# 42 HONEYSUCKLE DRIVE COTTAGE CREEK PRECINCT NEWCASTLE

STATE SIGNIFICANT DEVELOPMENT (SSD-10378)  
DEVELOPMENT MODIFICATION 2

ARCHITECTURAL DESIGN STATEMENT

NOVEMBER 2021

# 6.1 DESIGN CHANGES ROOF

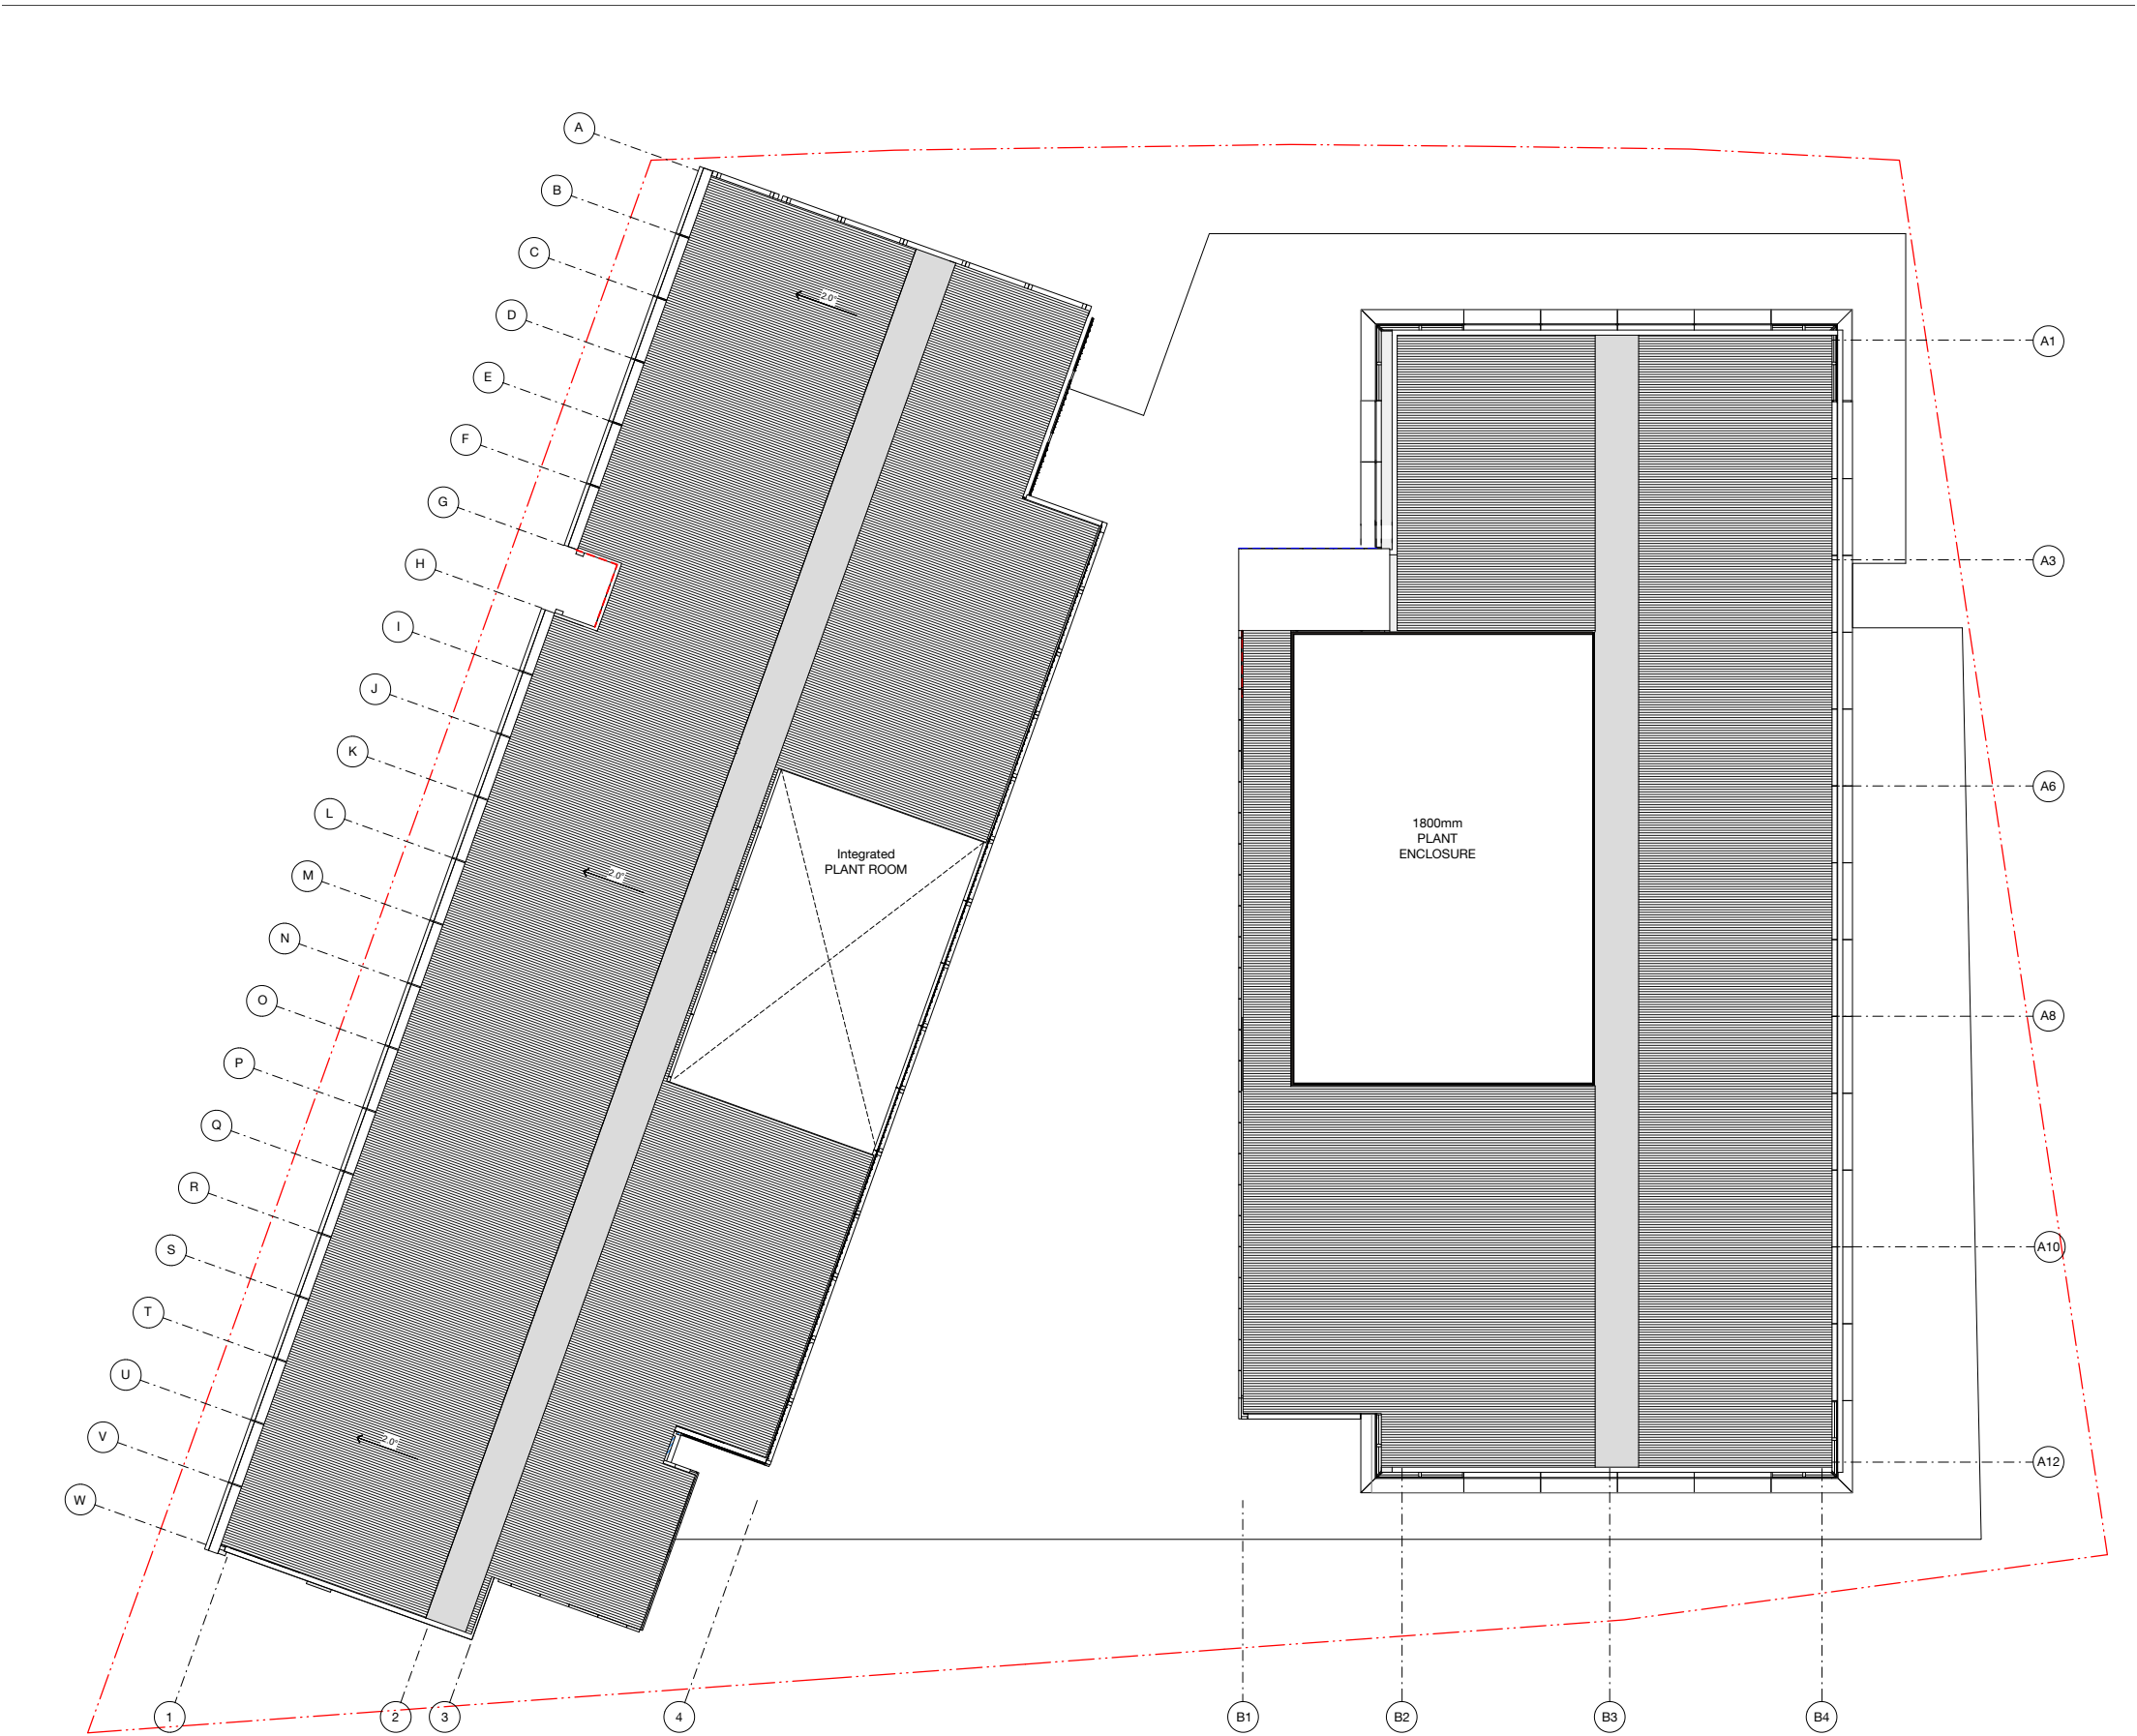
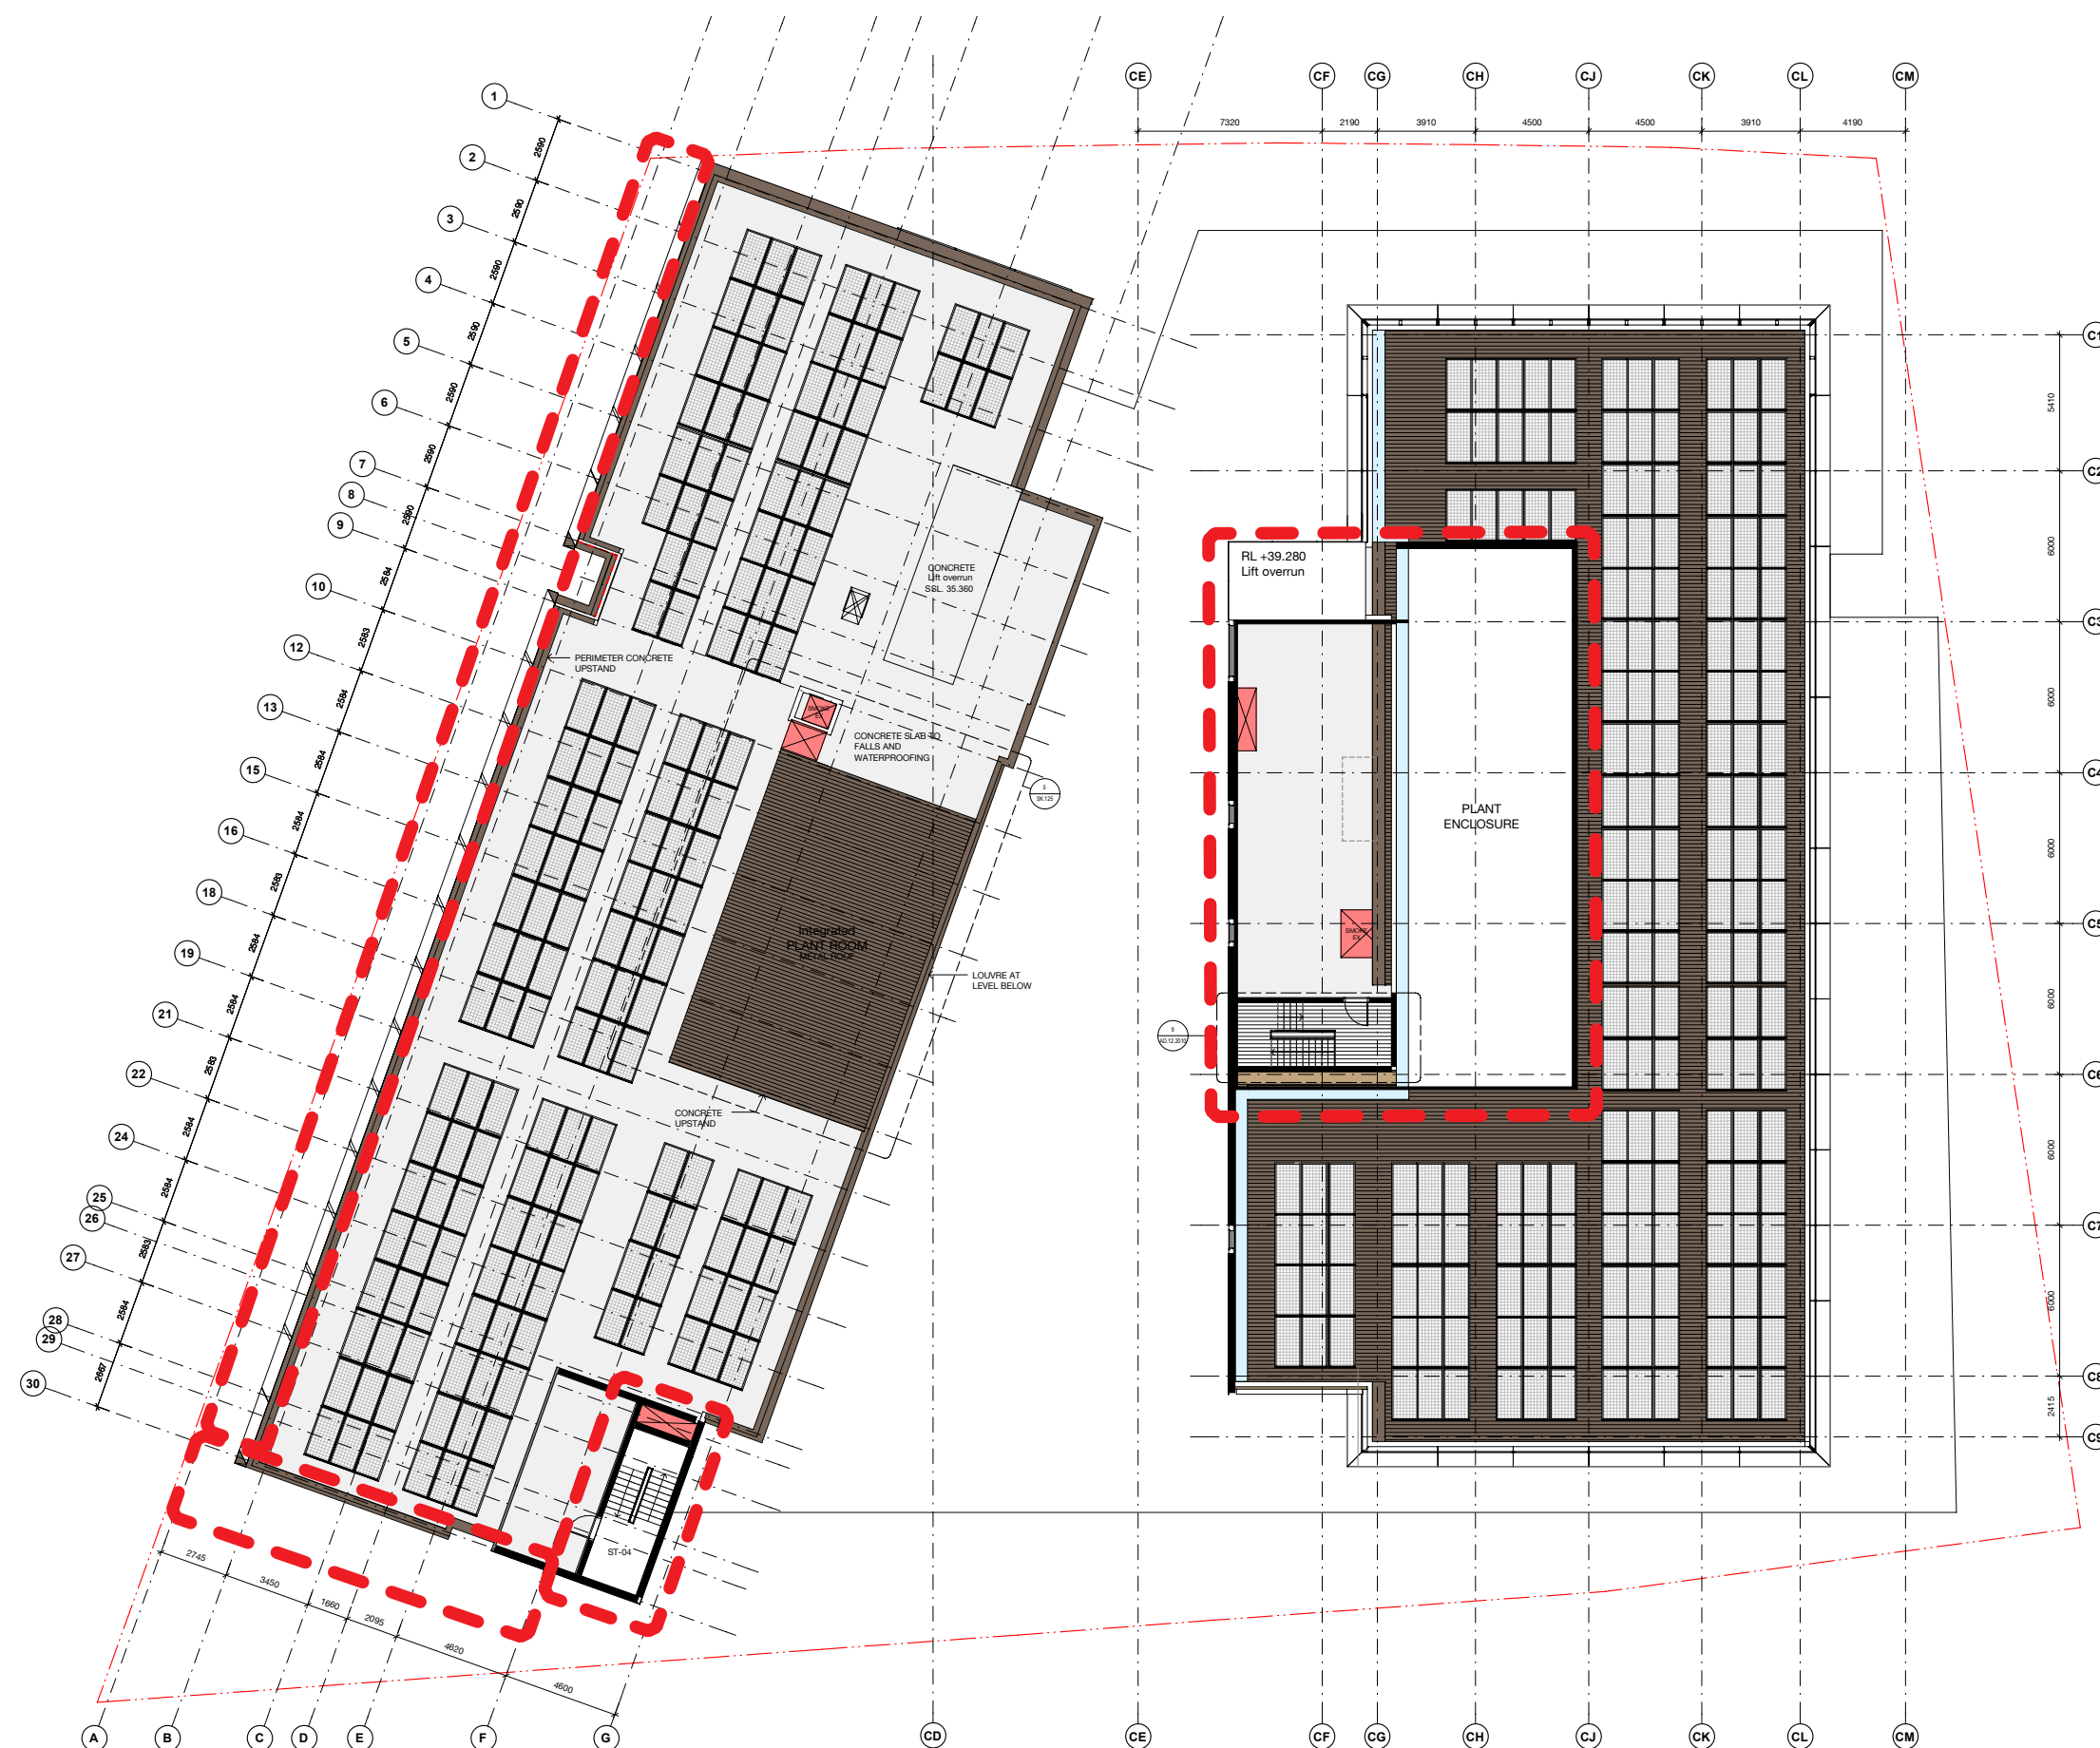
- 1 / South west end of the hotel - 1 room from every level omitted.
- 2 / Western hotel facade sunshading design amended
- 3 / Commercial tower external plant space increased in size
- 4 / Fire stair from commercial tower and hotel extended to roof access.
